SUBJECT: Forwards "NMP Unit 2 Safety Evaluation Summary Rept" & rev 8  
to "Updated SAR for NMP Unit 2."

**Subject: SUBMITTAL OF REVISION 8 TO THE NINE MILE POINT NUCLEAR  
STATION UNIT 2 UPDATED SAFETY ANALYSIS REPORT AND THE  
ANNUAL 10 C.F.R. §50.59 SAFETY EVALUATION SUMMARY REPORT**

Pursuant to the requirements of 10 C.F.R. §50.71(e) and 10 C.F.R. §50.59(b), Niagara Mohawk Power Corporation hereby submits Revision 8 to the Nine Mile Point Nuclear Station Unit 2 Updated Safety Analysis Report (USAR) and the annual Safety Evaluation Summary Report.

FIGURE 1.2-1

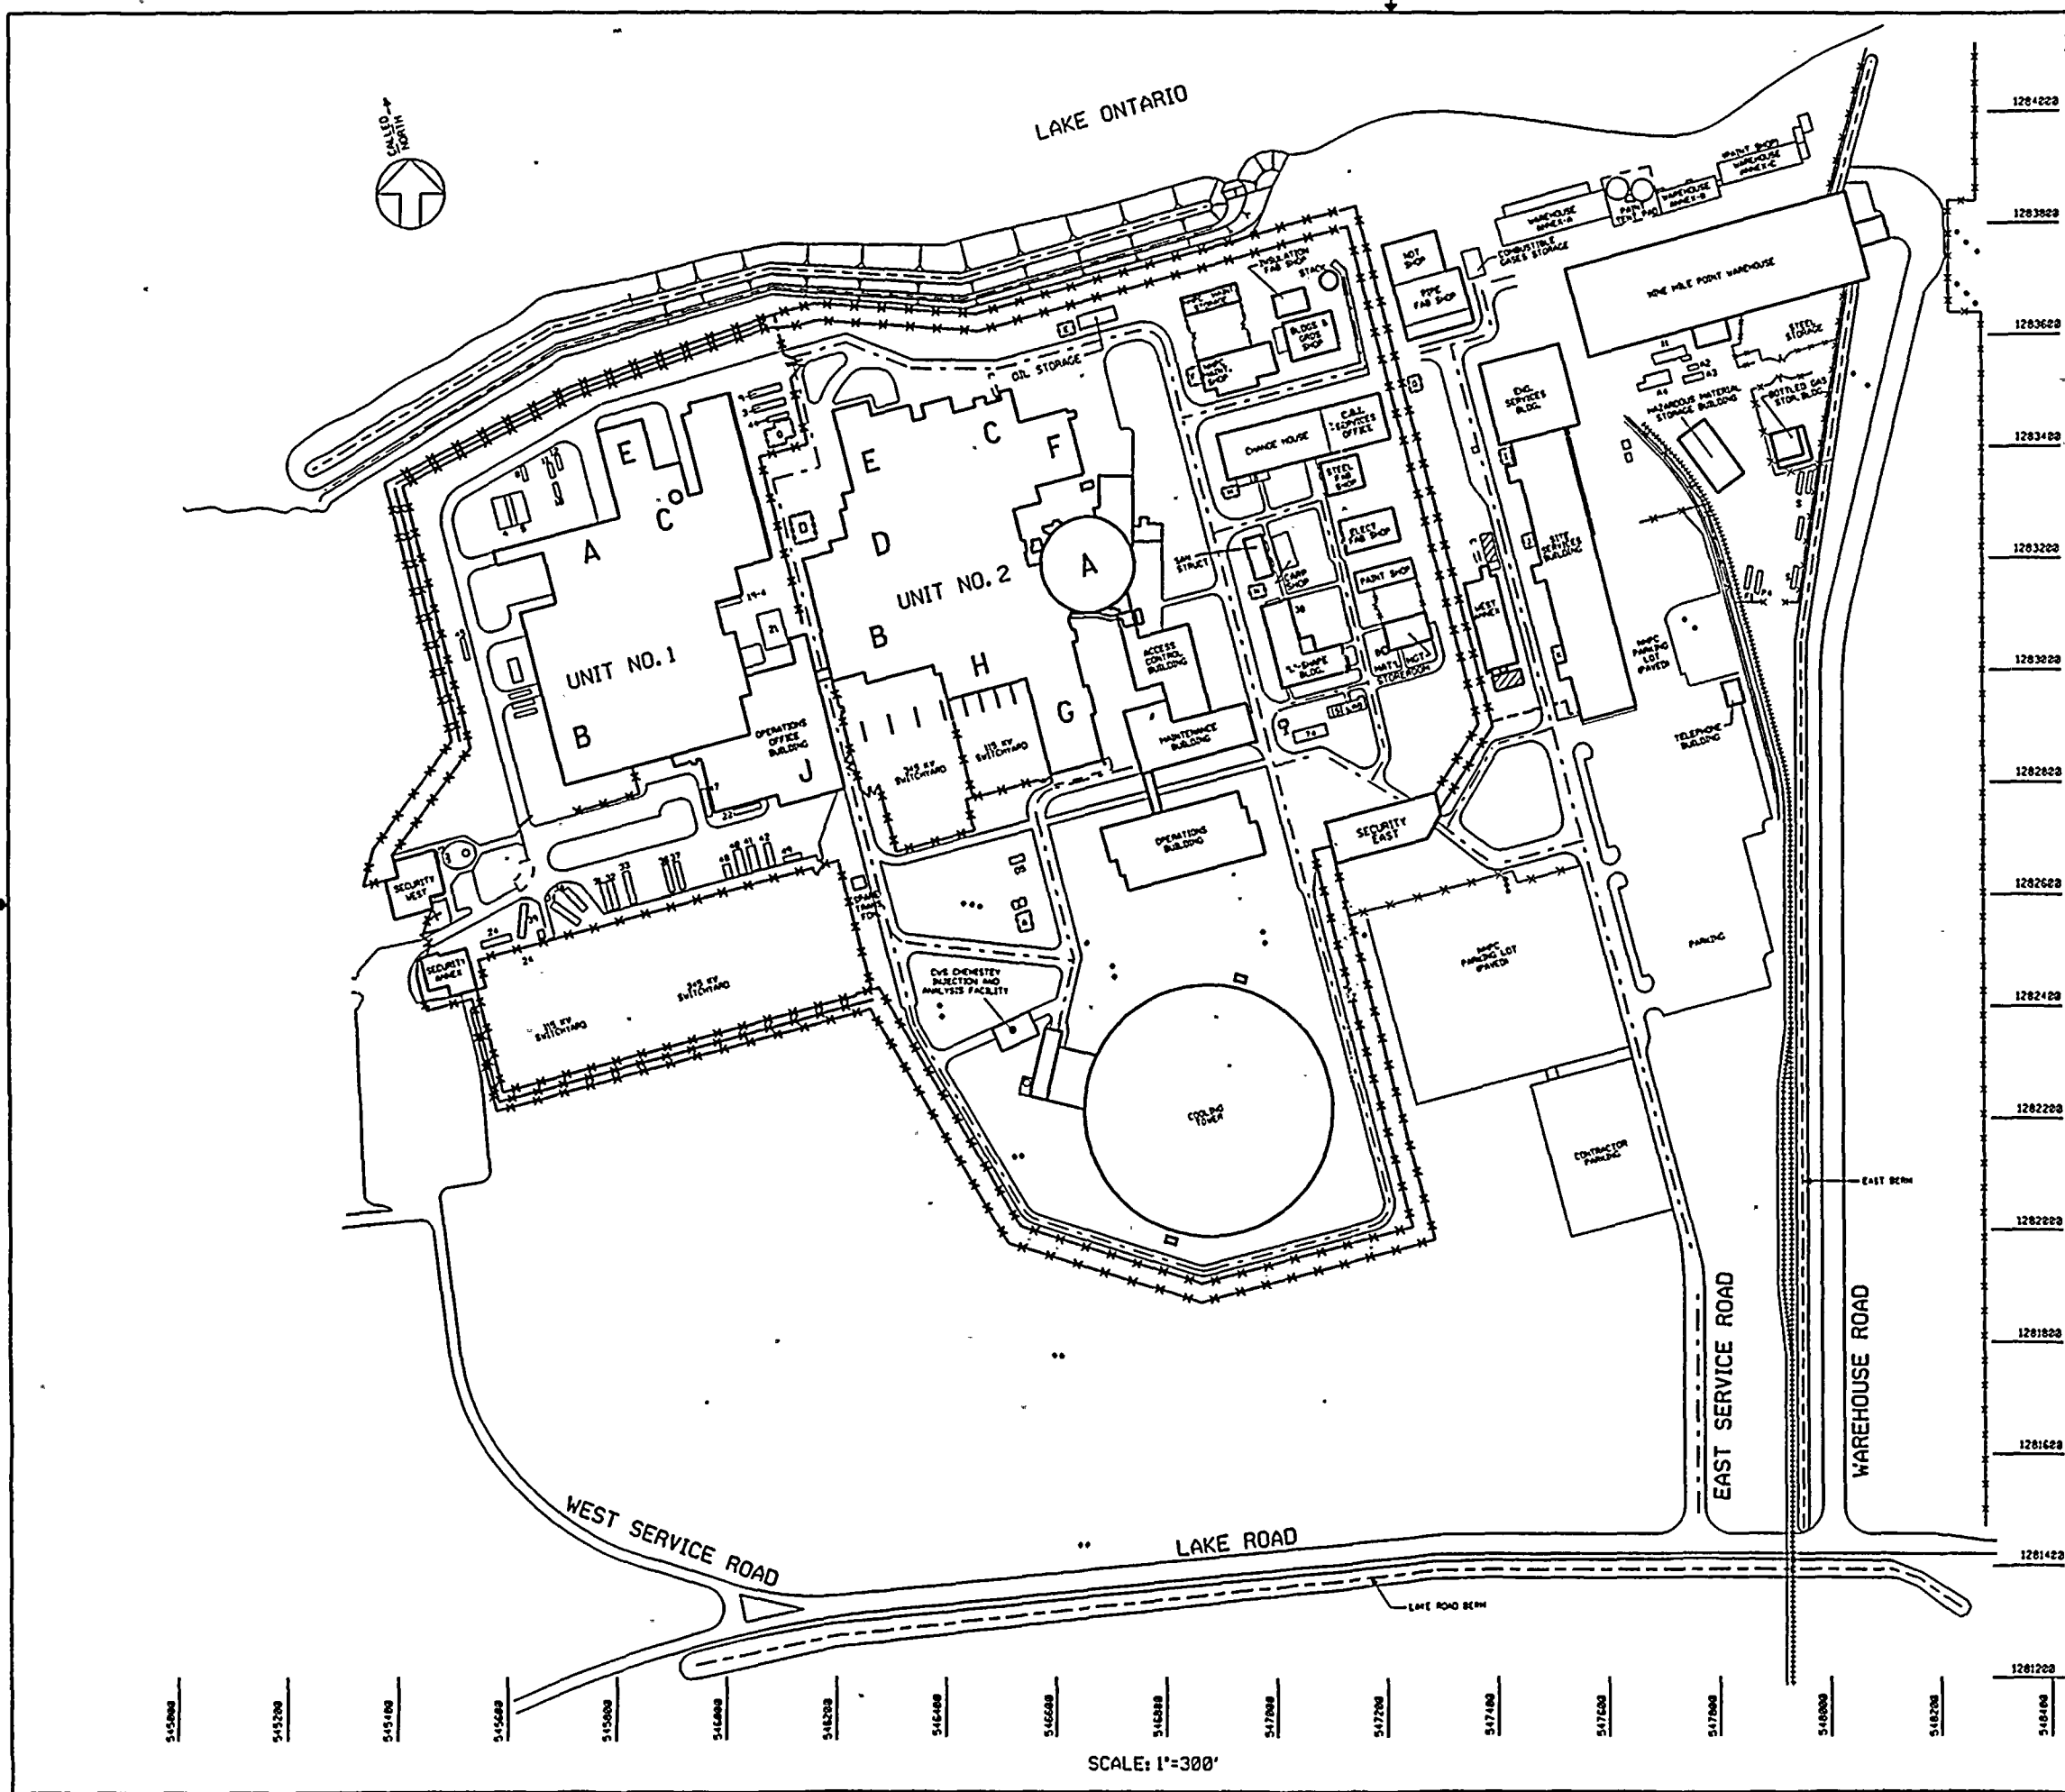
**Safety Evaluation No.:** 93-056 Rev. 1, 2 & 3  
**Implementation Document No.:** Simple Design Change SC2-0328-92  
**USAR Affected Pages:** Figures 1.2-1, 2.4-1  
**System:** N/A  
**Title of Change:** Construct a Spare Transformer Facility

**Safety Evaluation No.:** 93-129  
**Implementation Document No.:** N/A  
**USAR Affected Pages:** Figures 1.2-1, 2.4-1, 9A.3-1  
**System:** N/A  
**Title of Change:** Construction of the New Engineering Services Building

**Safety Evaluation No.:** 94-058  
**Implementation Document No.:** Drawing EY-8S  
**USAR Affected Pages:** Figure 1.2-1  
**System:** N/A  
**Title of Change:** New Structures to Connect Unit 2 Access Control Building to the Plant

FIGURE 1.2-40

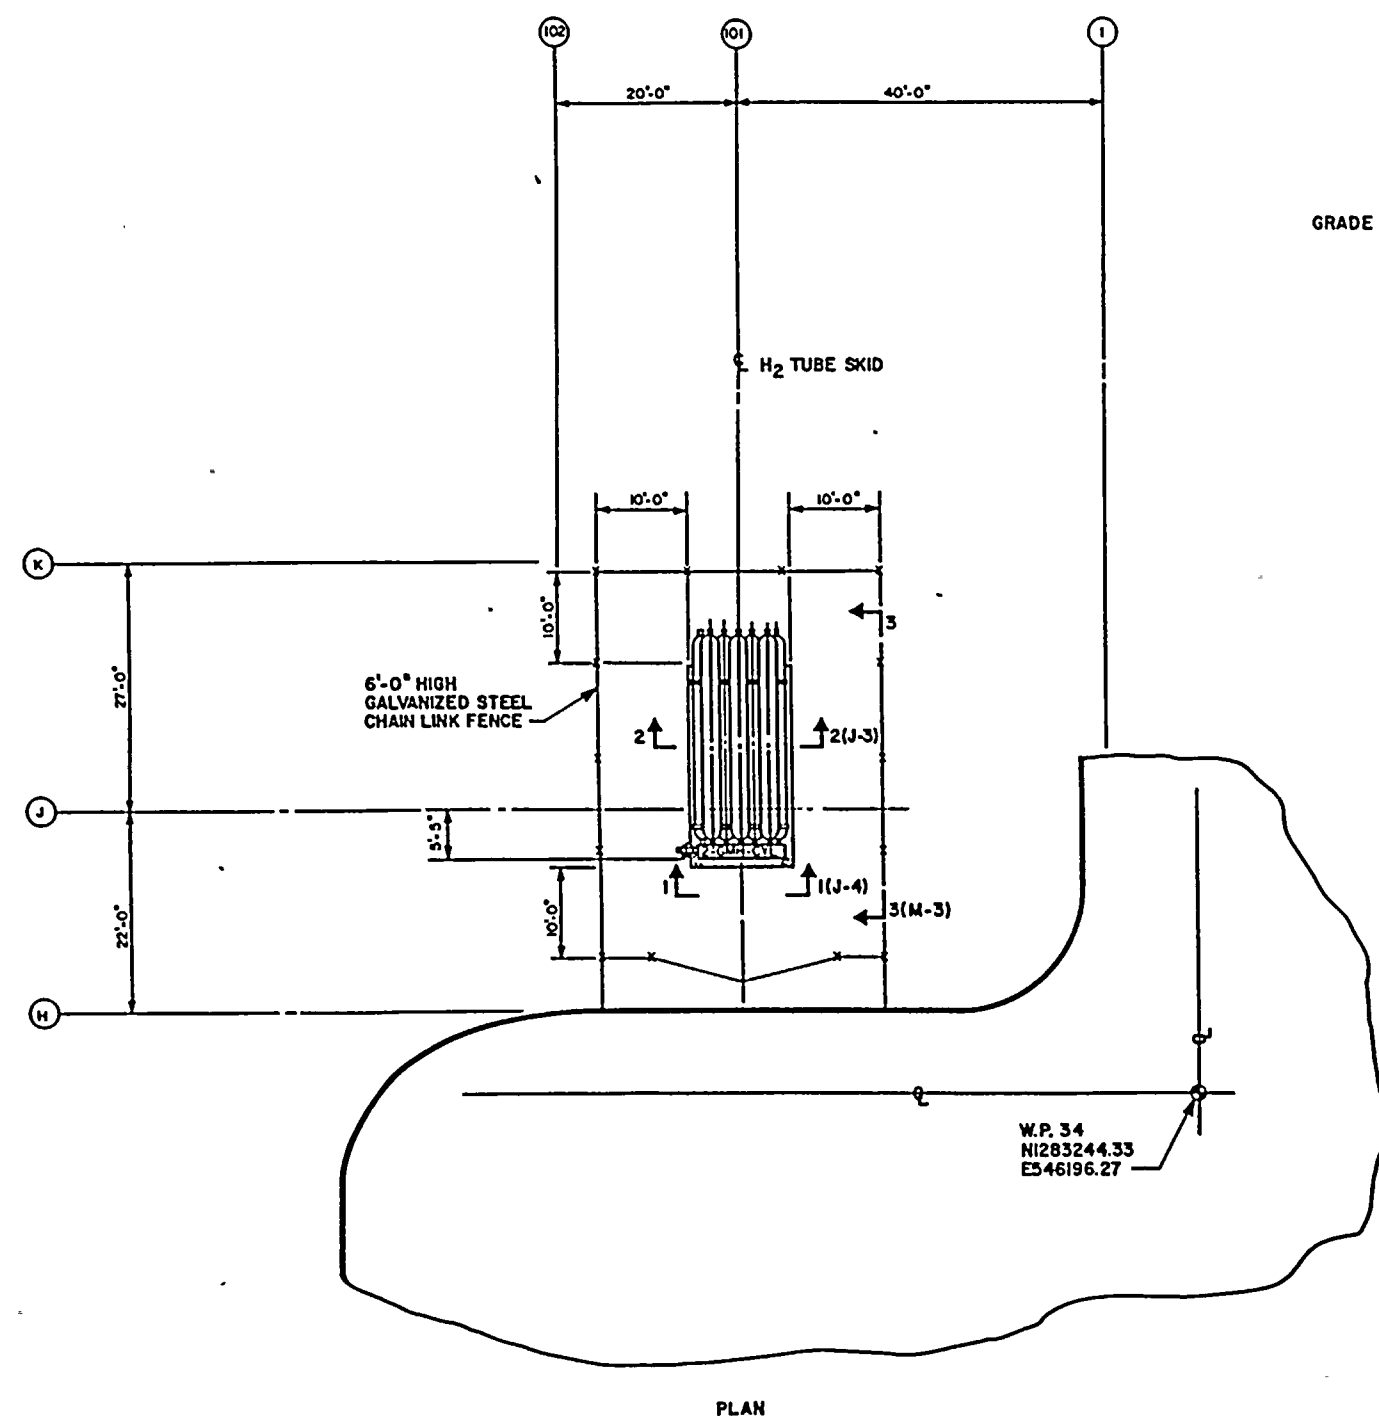
**Safety Evaluation No.:** 94-046 Rev. 1  
**Implementation Document No.:** Simple Design Change SC2-0099-93  
**USAR Affected Pages:** 10.2-4, 10.2-5; Figure 1.2-40  
**System:** Generator Hydrogen Supply (GMH)  
**Title of Change:** Bulk Hydrogen Control Cabinet
